Part Number Update

Bulletin No: PNU-252

subject: Bendix® ACom® Diagnostic Software - Mandatory Update

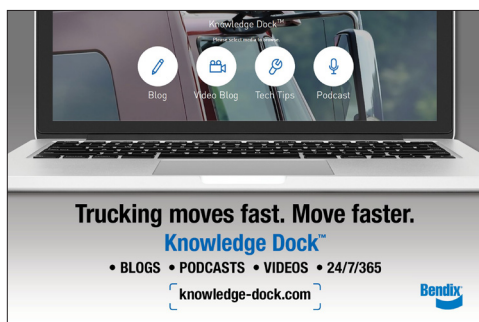
The following confirmation dialog box will be displayed when the new version of ACom diagnostic software (v6.16.5.2 or greater) detects a controller with this condition and repairs it.
